ADDENDUM 1 (PENDING DSA APPROVAL)

PROJECT: **Santa Ana College**
 Science Center

DATE: 8/23/2017

DSA File No.: 30-C2
DSA Applications No.: 04-115788
HGA Commission No.: 3584-001-00

PLUMBING SECOND LEVEL PLAN

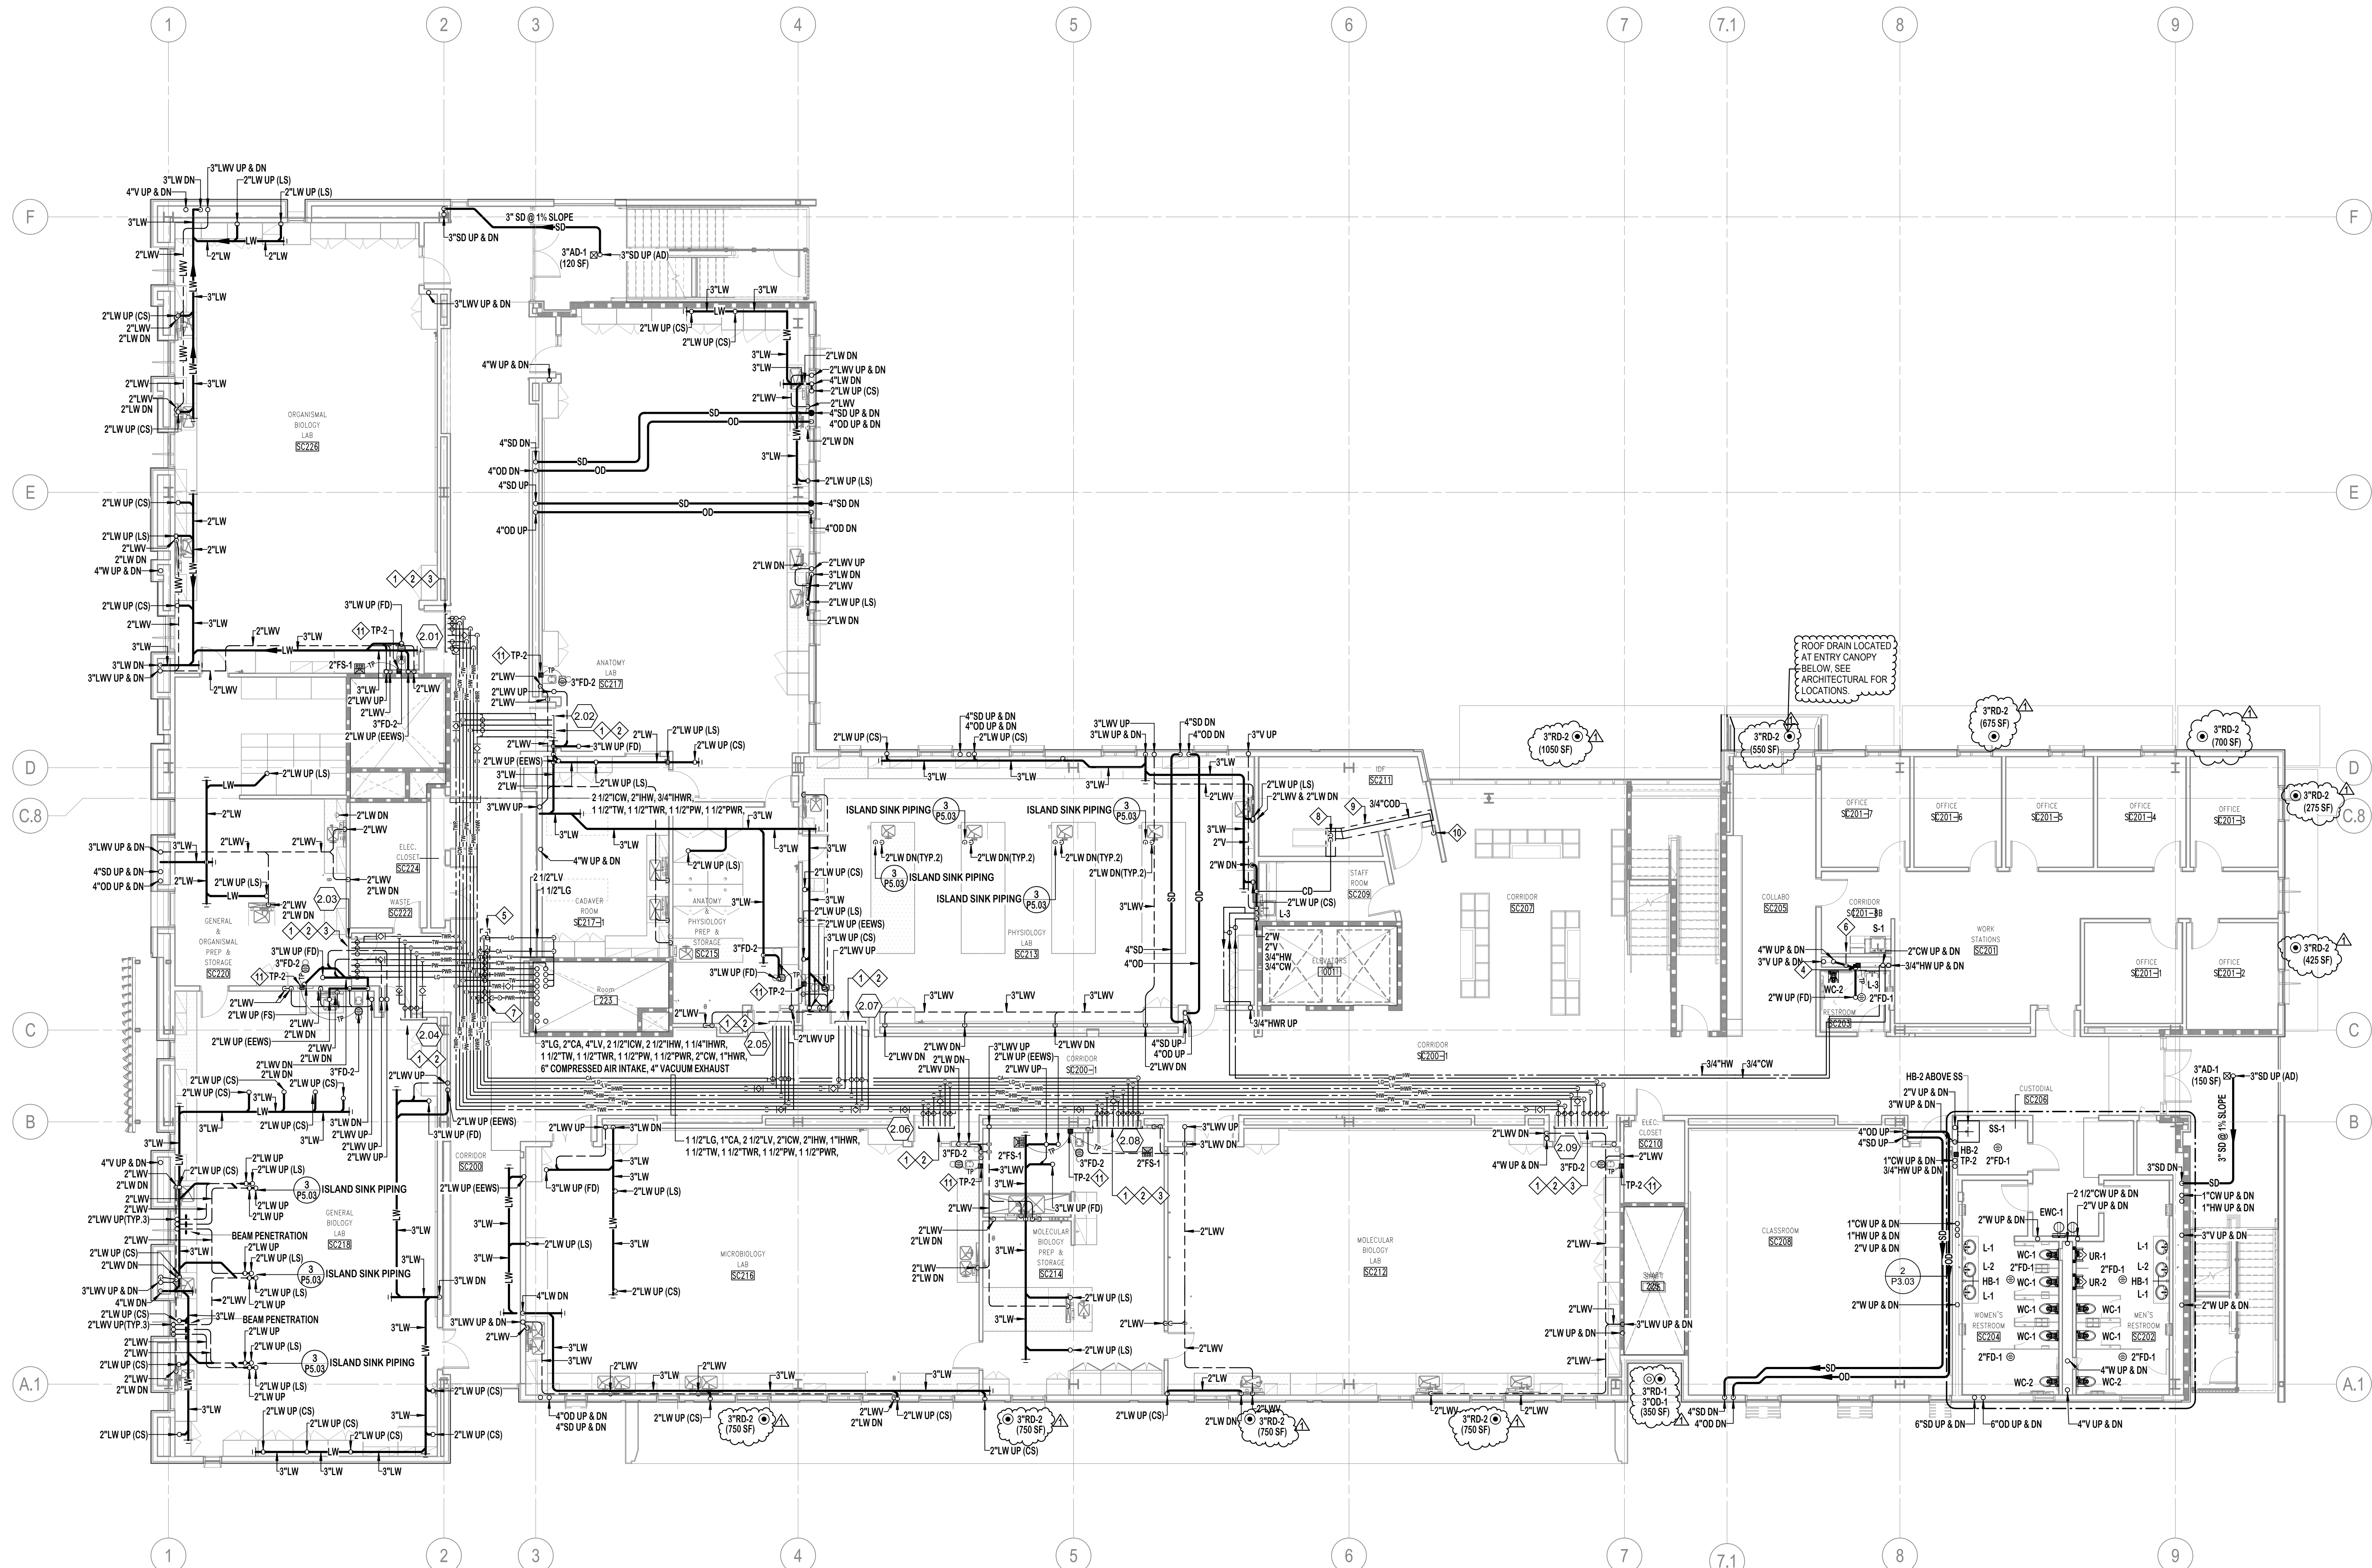
- Reflected RD-2 in north and south canopy areas.
- Reflected storm and overflow drains in south side of building

**STORM DRAIN
RISER DIAGRAM**

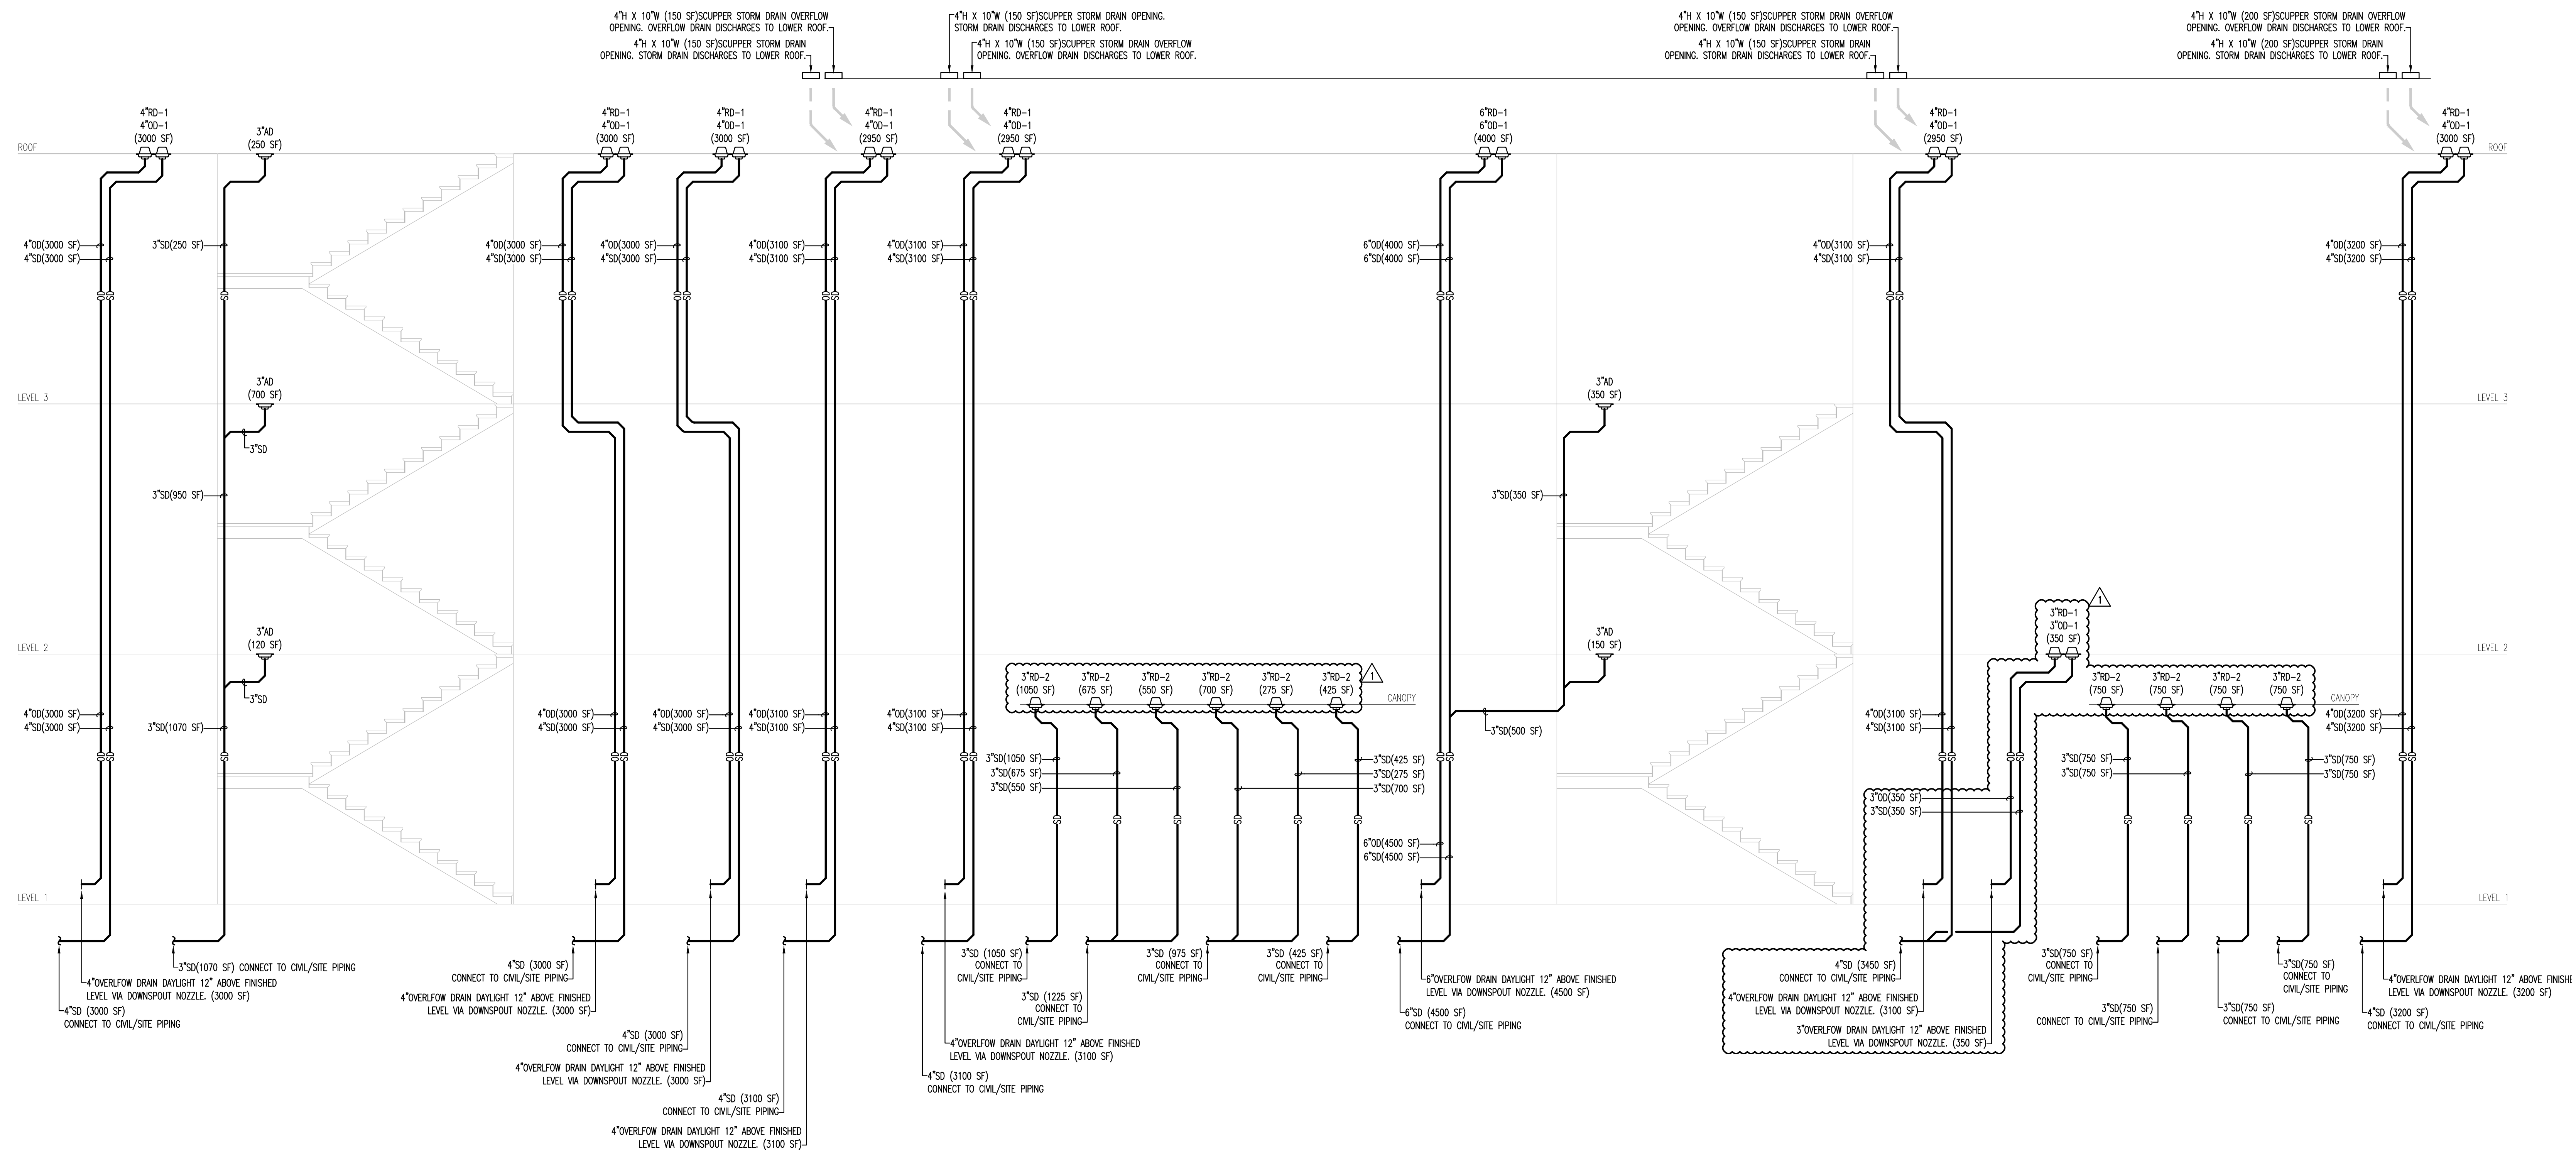
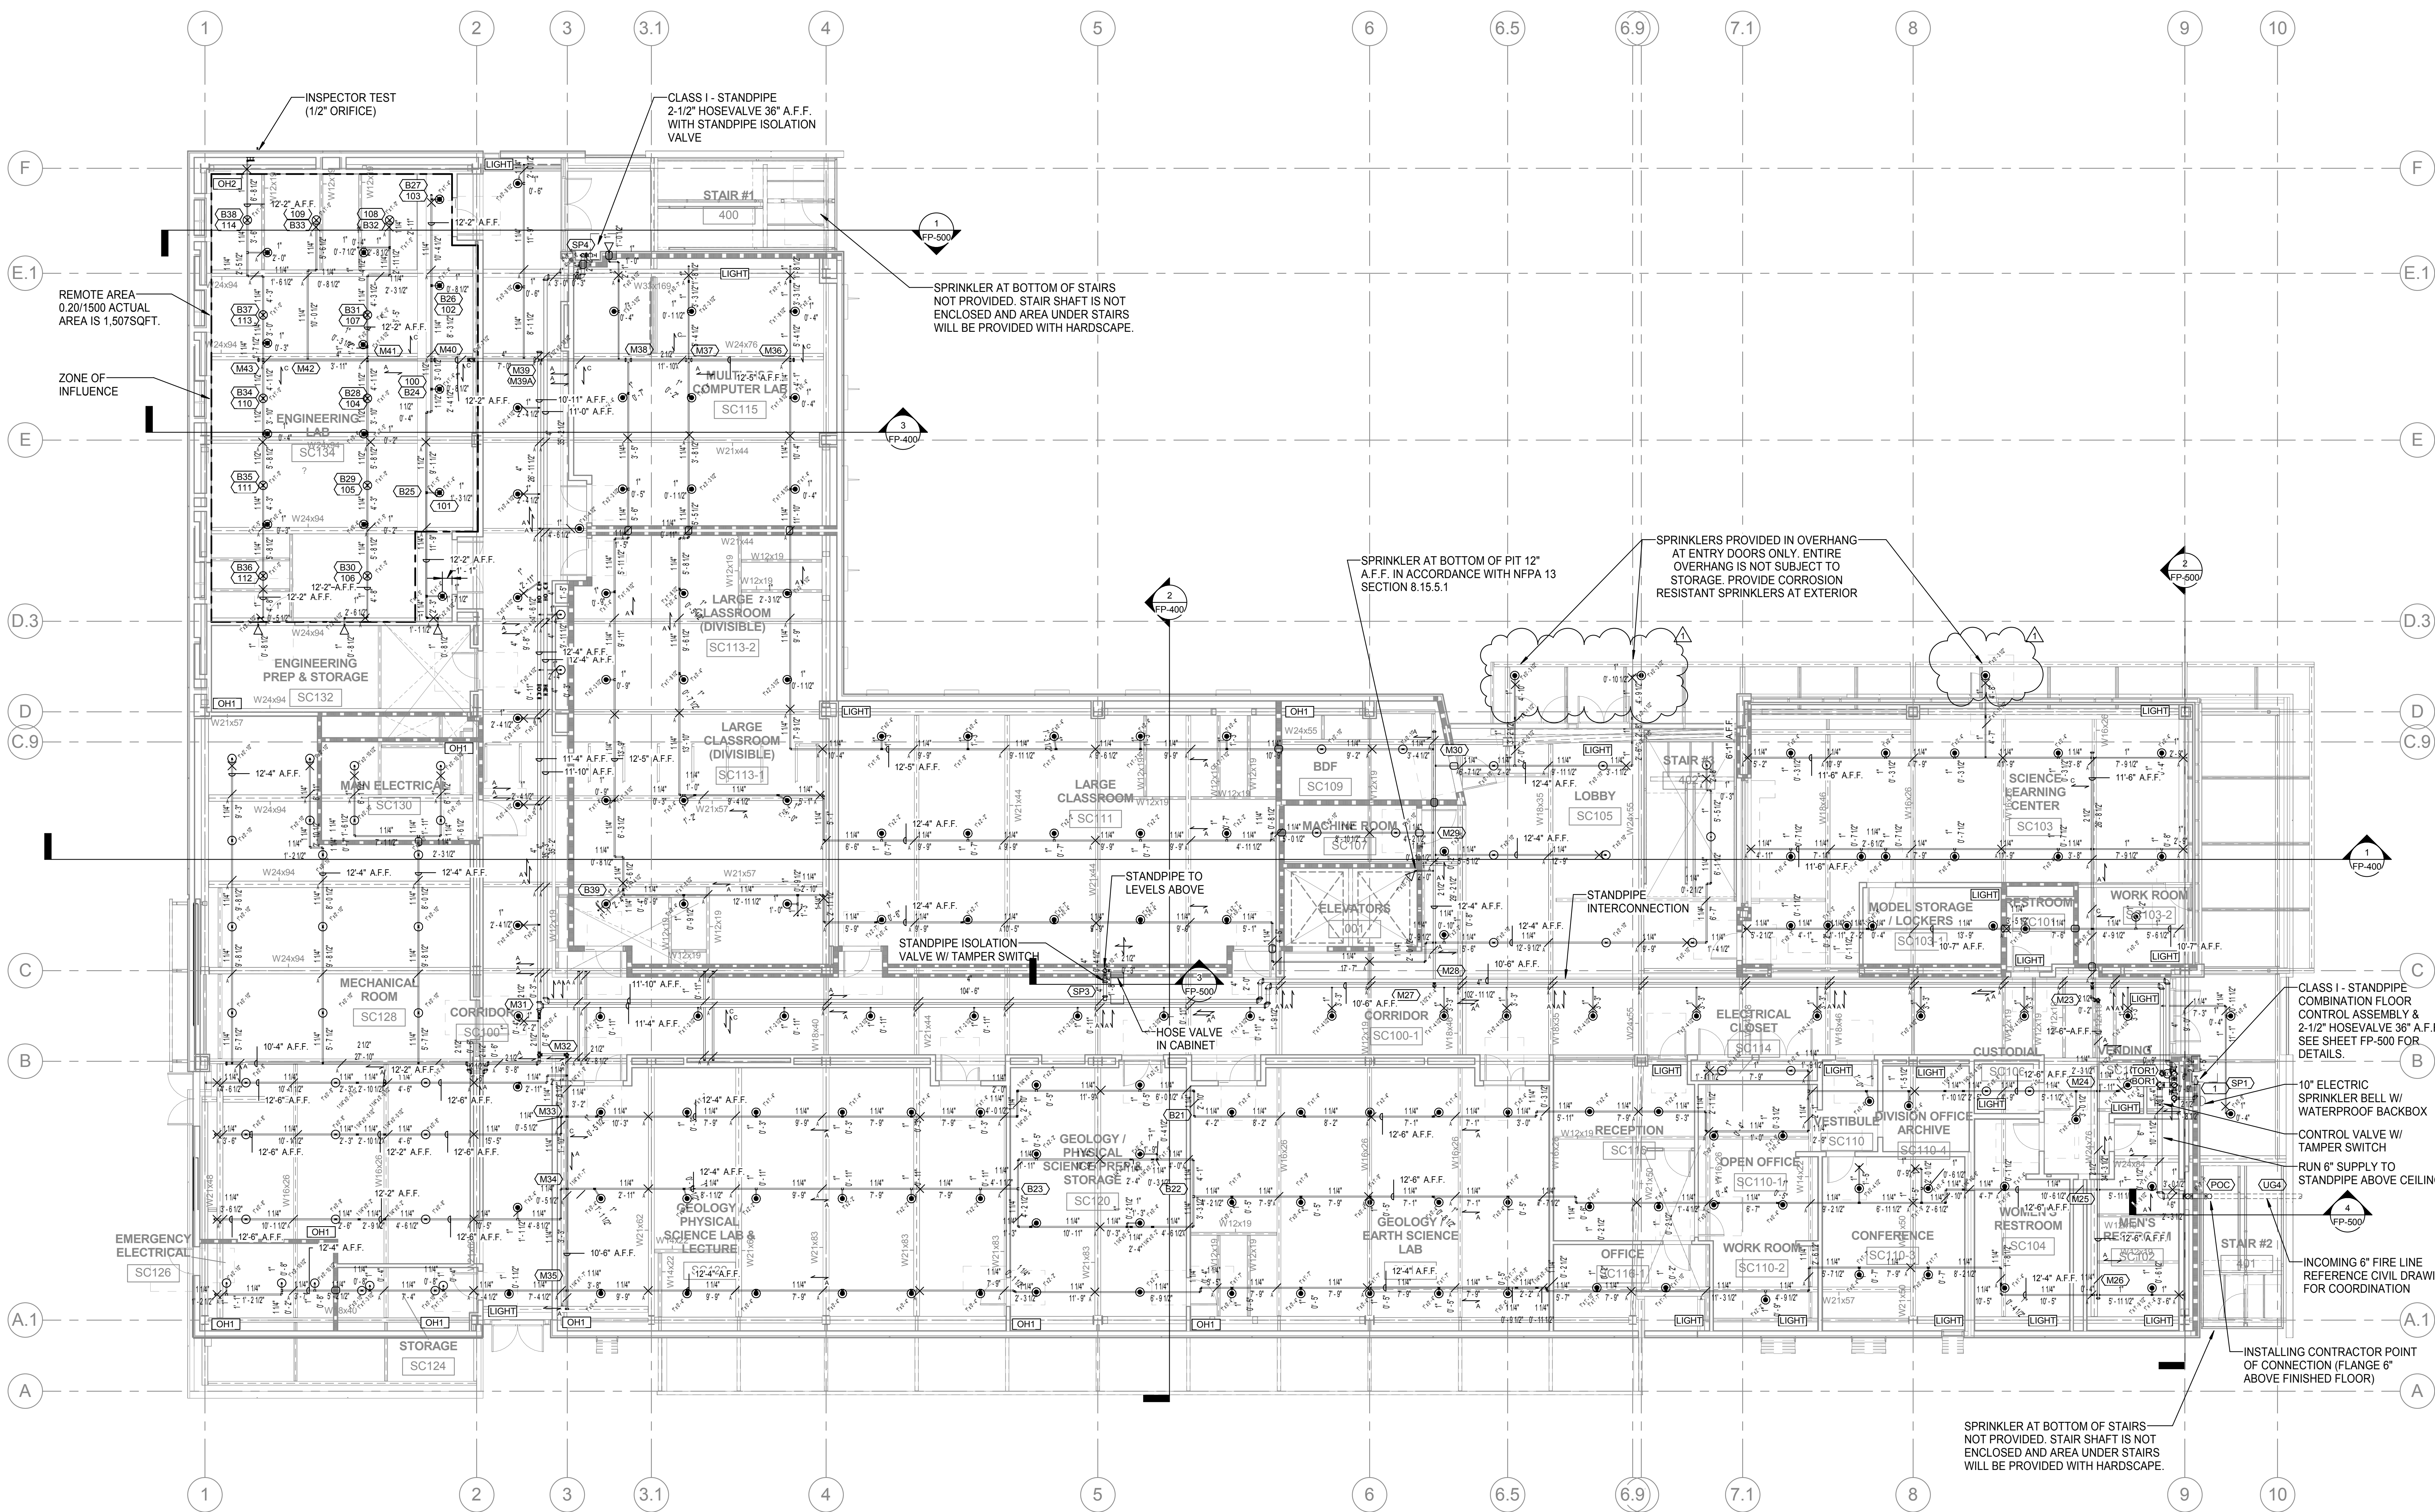
- Updated storm drain riser diagrams per changes.
